工程指示 / 要求簡箋(E.I.)

工程指示編號：EI / 6987 / 23

工程名稱：將軍澳日出康城

工程項目：T1-T3 蕃薯門 地盤用 玻璃 BM 特色層 共21件 按12th 門窗圖

Unit: 6-8, Sunny Industrial Centre, 1/F, 610 Che Kwo Ling Road, Kowloon Tel: 24248211-4 Fax: (852) 2727656 DWG NO. : J858-W-2103d REV. : B

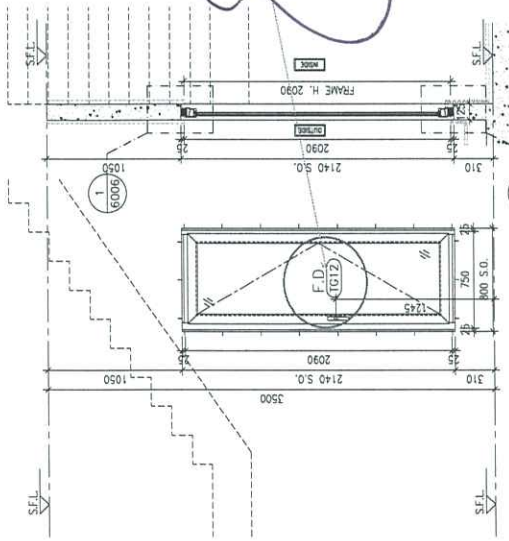
Comment

Change to TG09, same type of glass used in bathrooms

6+6 Lam.
